ADDENDUM NO. CC-2

STATE OF NEBRASKA  
TSB – EXTERIOR RENOVATION  
LINCOLN, NEBRASKA  
DLR GROUP PROJECT NO. 10-09206-30

September 13, 2012

NOTICE TO BIDDERS: Amend the Project Manual and Drawings to the above referenced project as follows:

14TH STREET STOREFRONT ENTRANCE  
TSB EXTERIOR RENOVATION  
1400 "M" ST. LINCOLN, NE

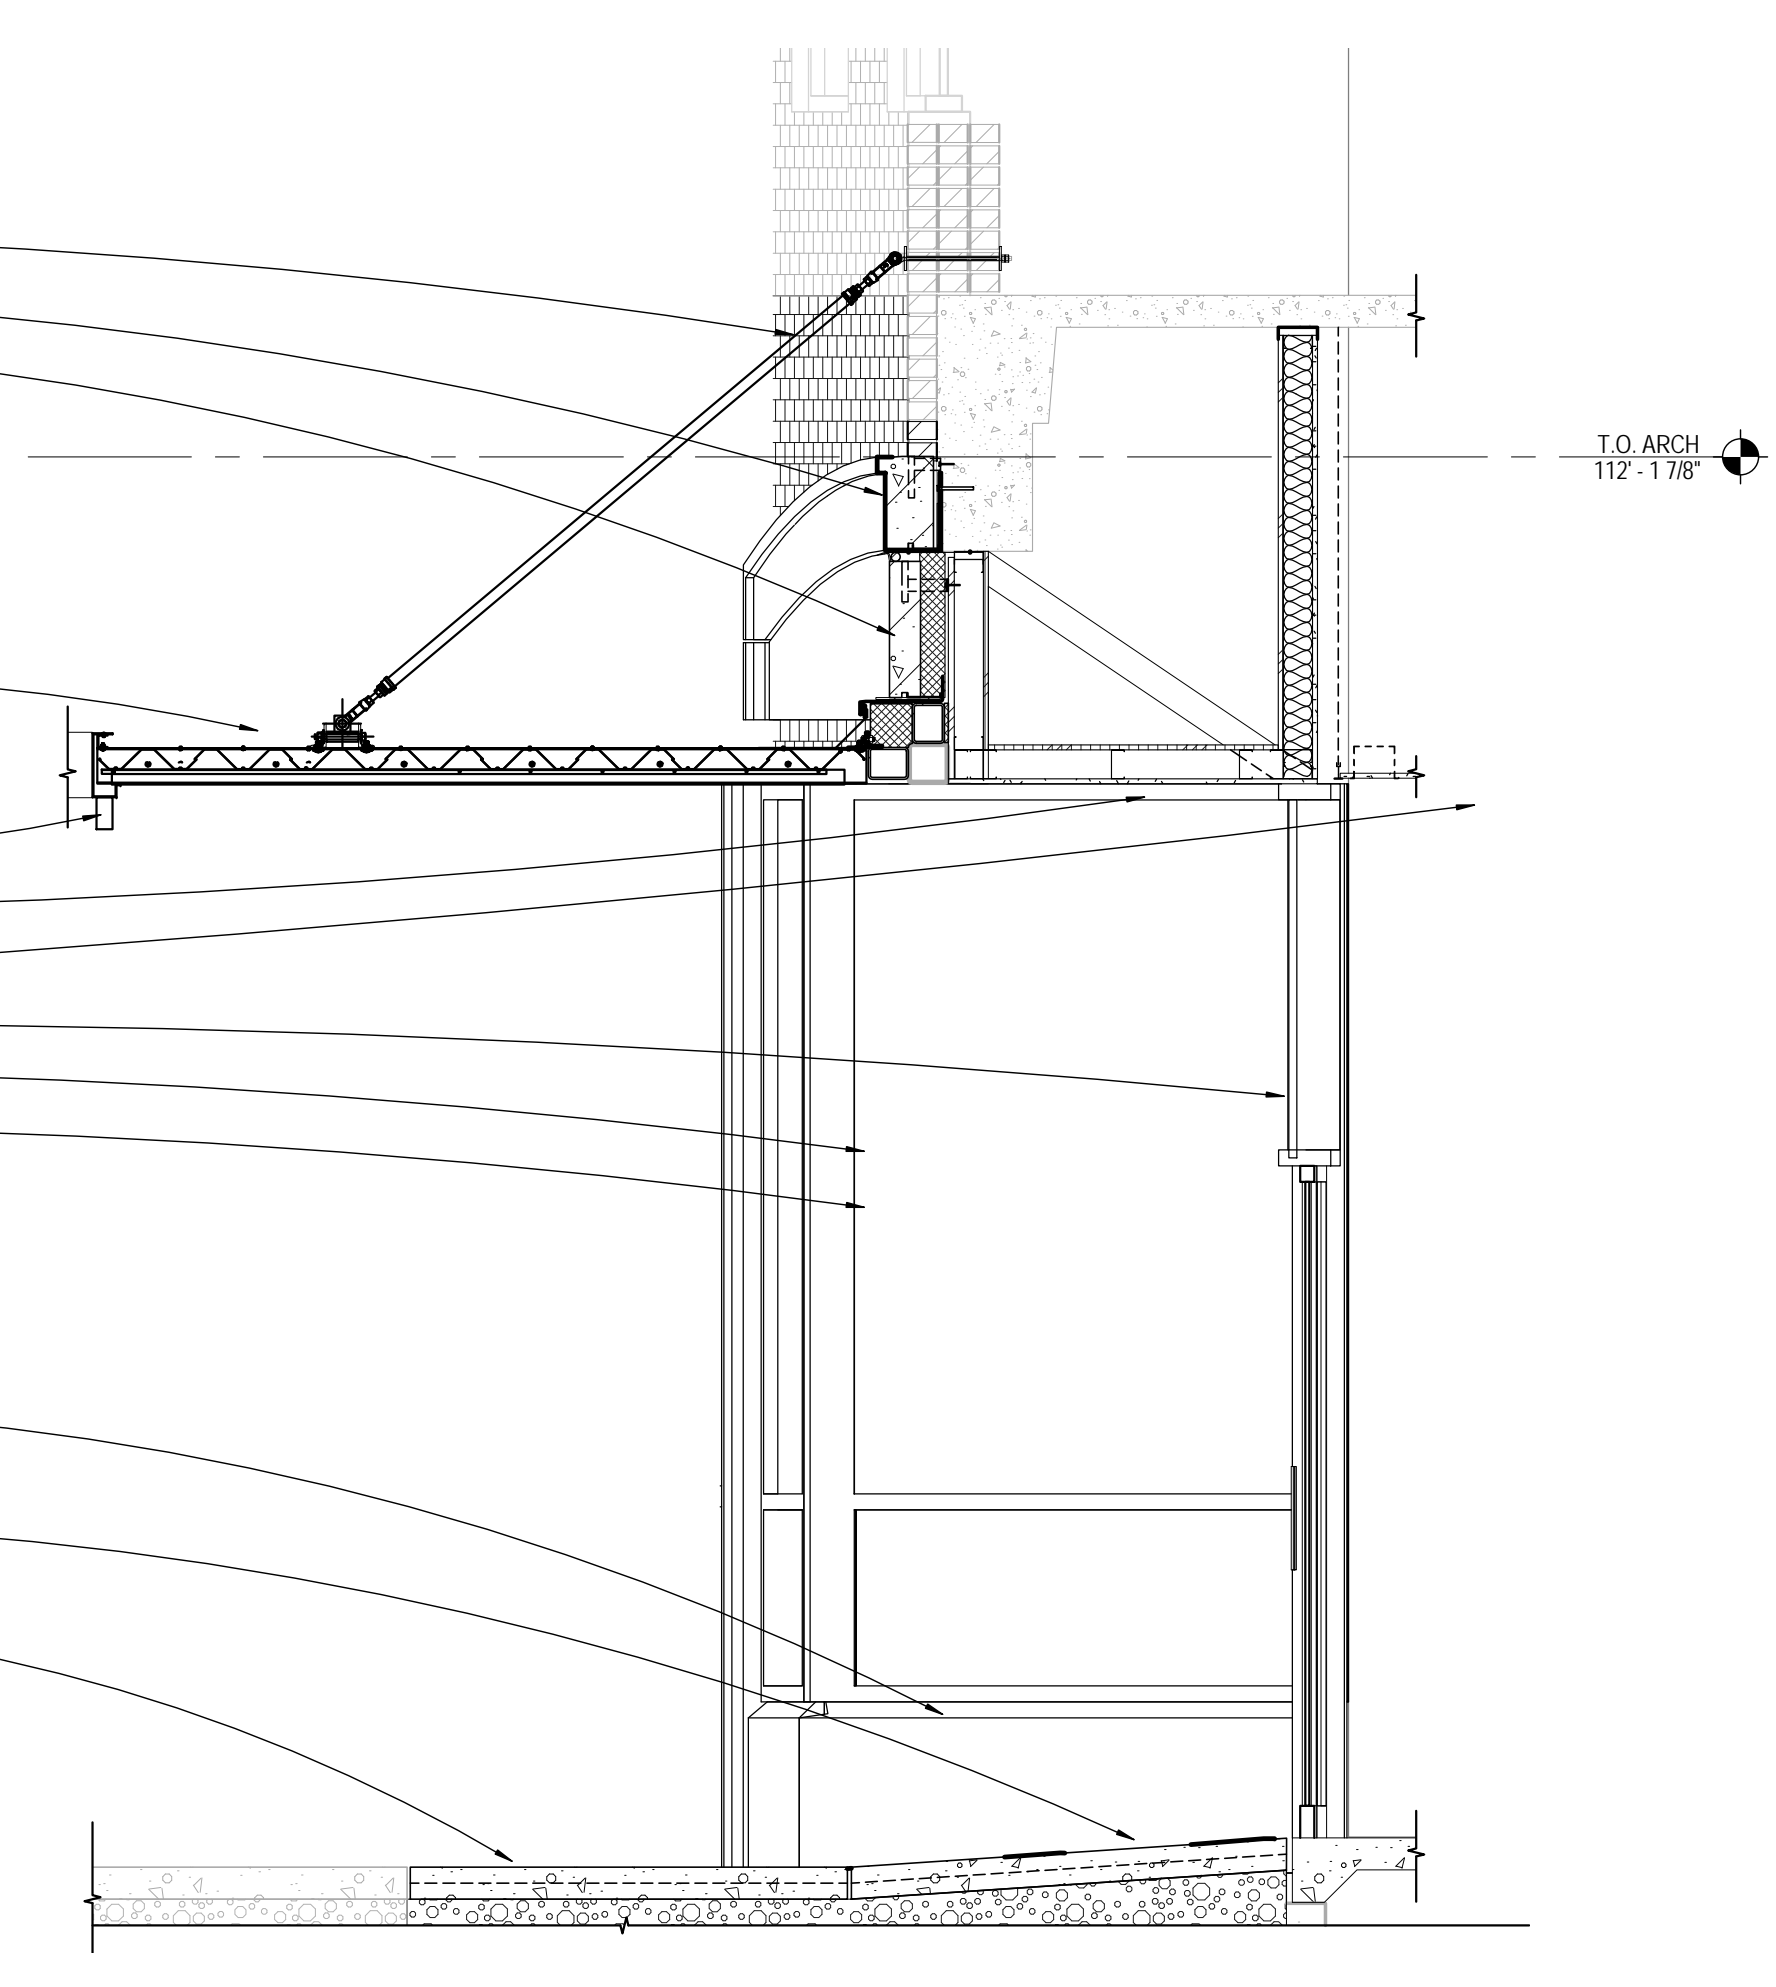
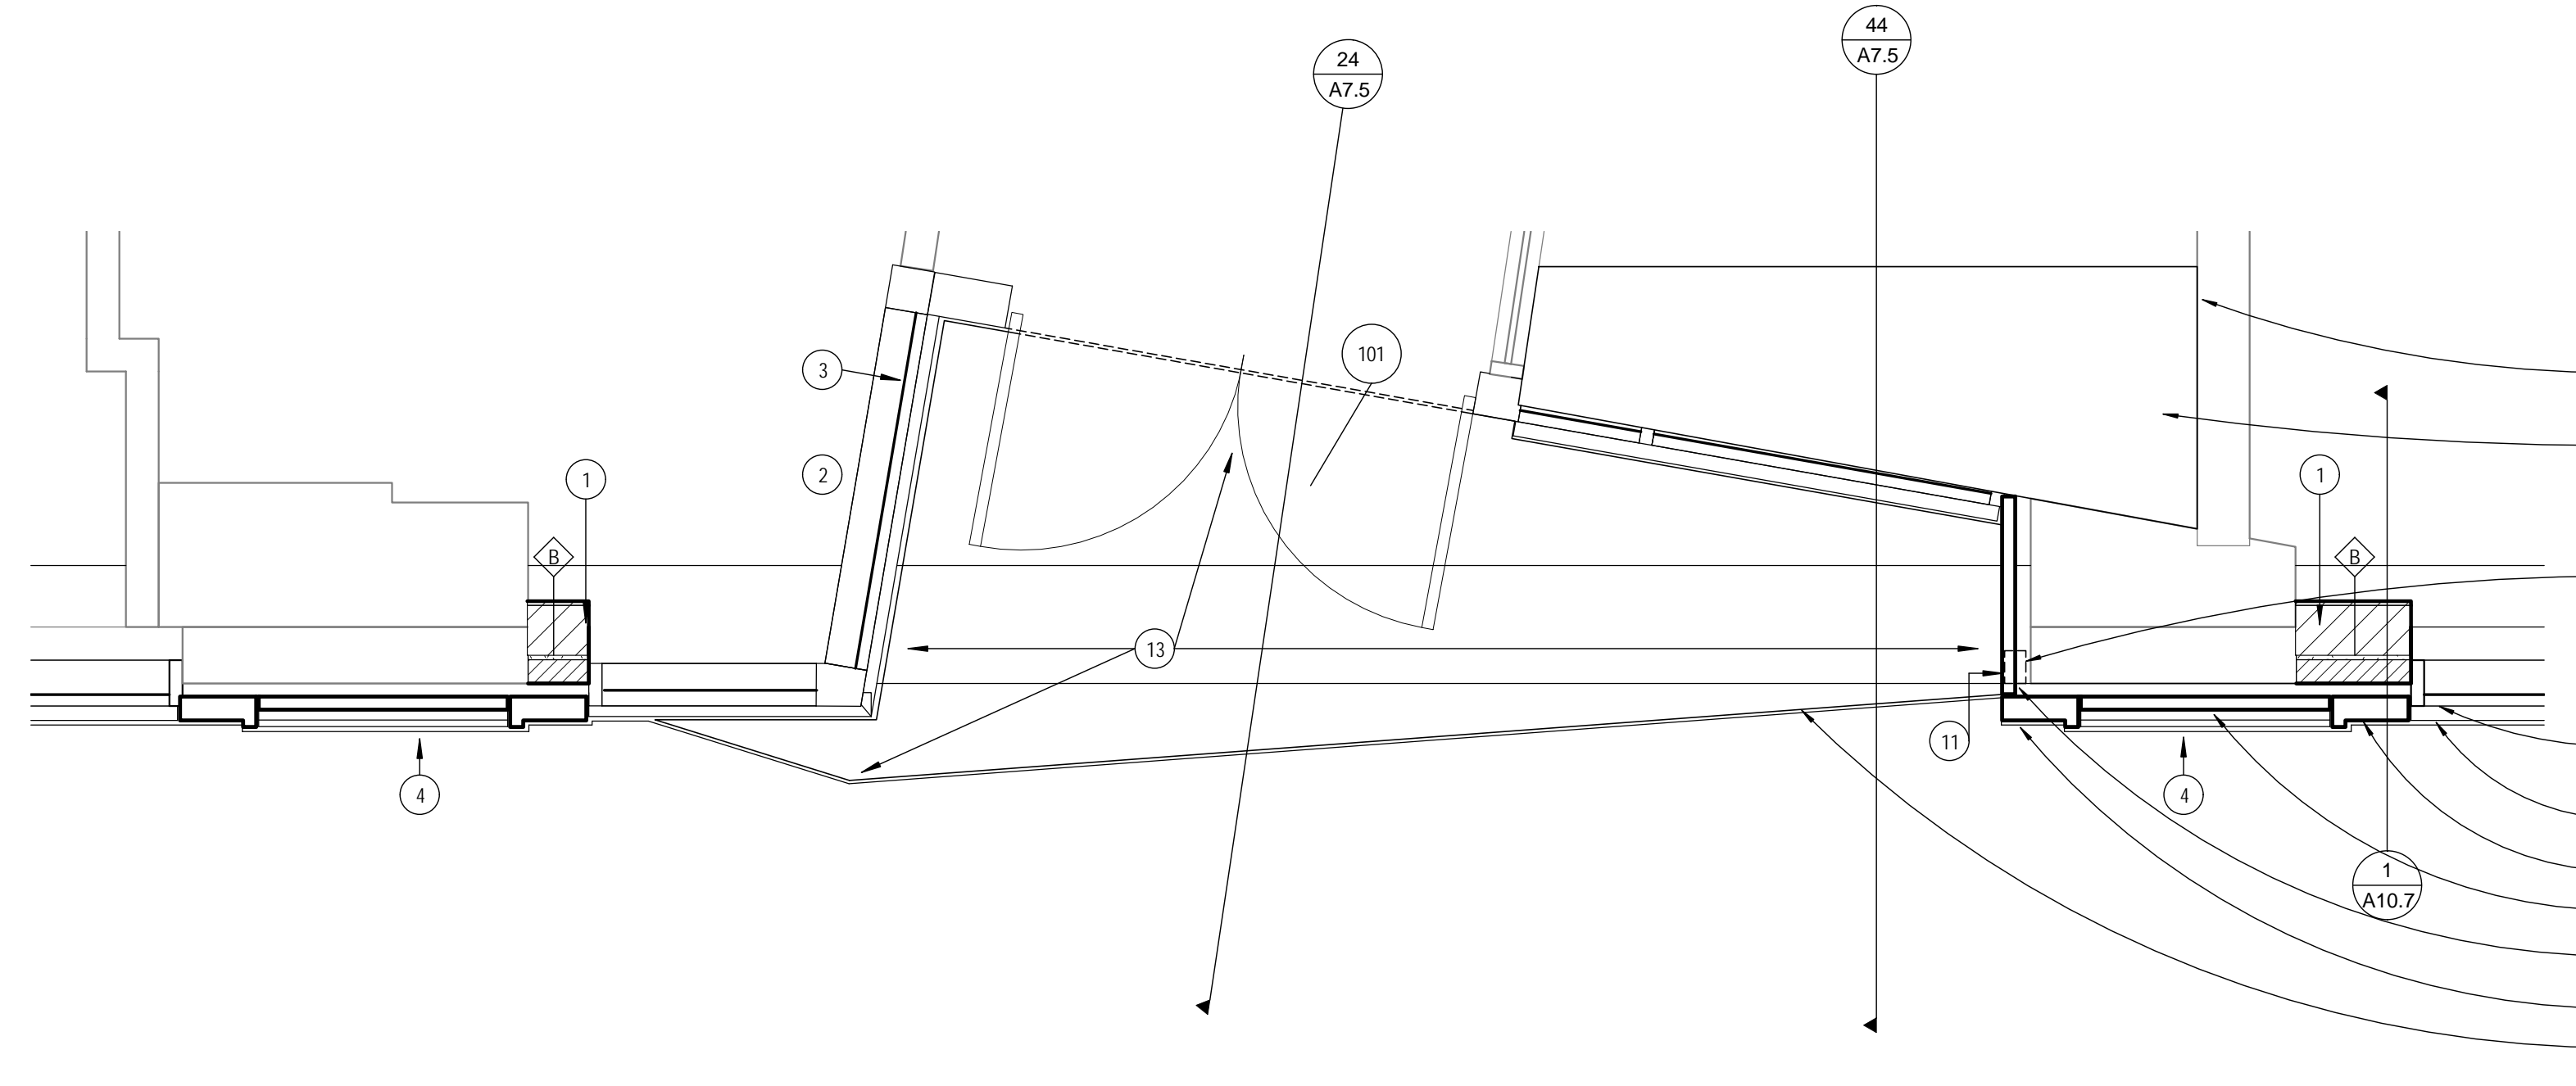
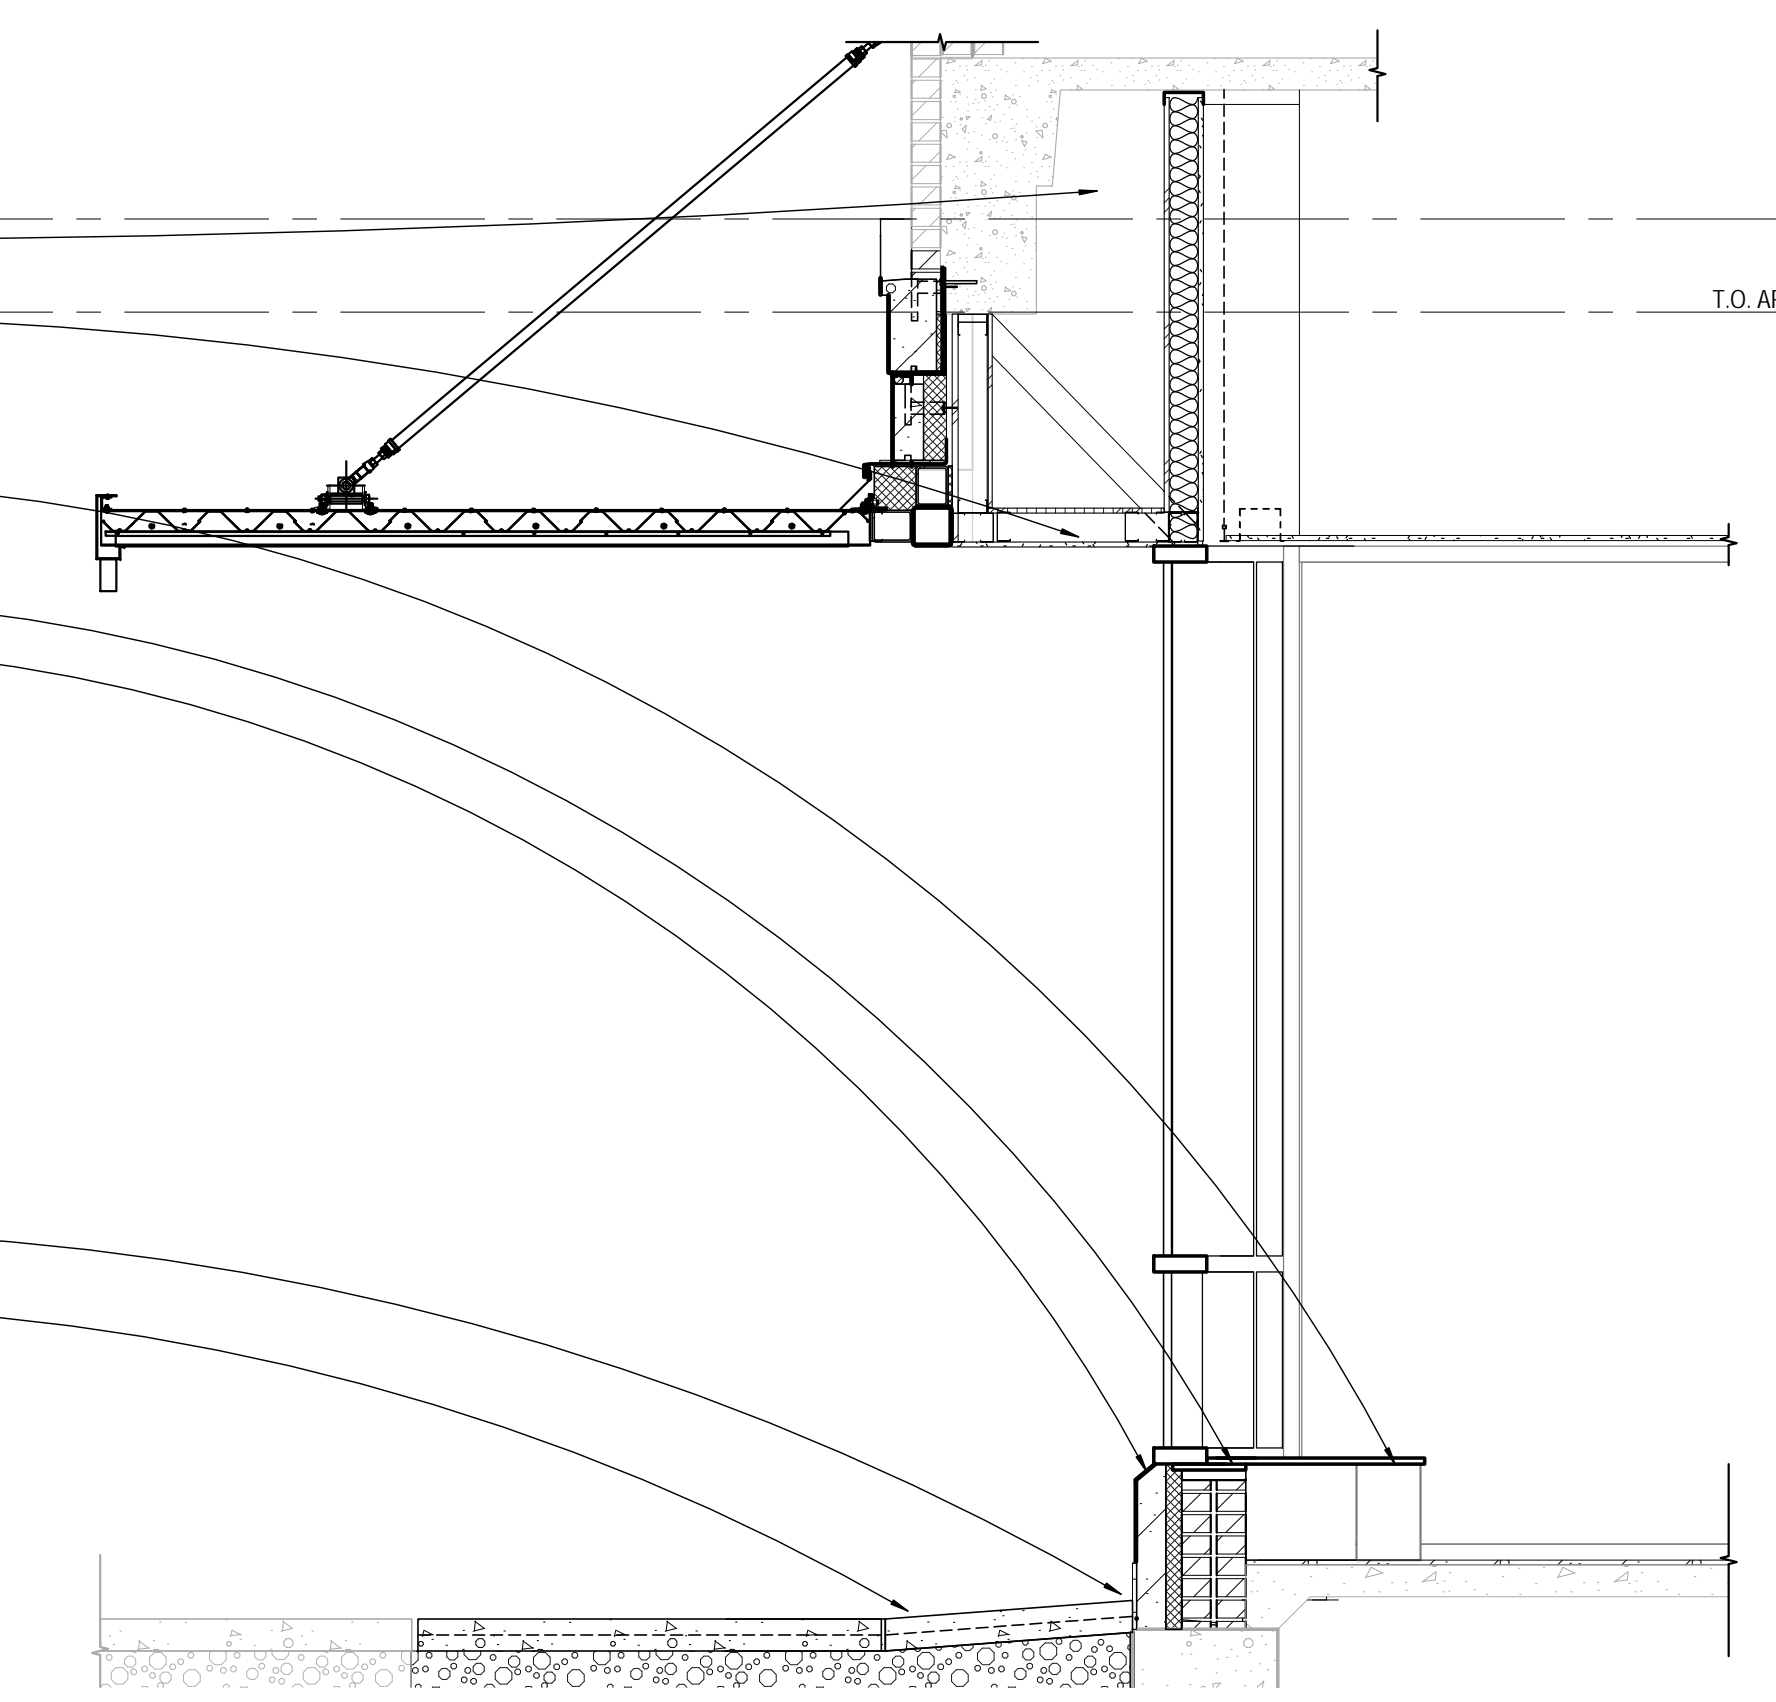
ITEM NO. 11 DRAWING A7.5 - 14<sup>TH</sup> STREET

A. Modify all drawing as shown on Drawing A7.5.
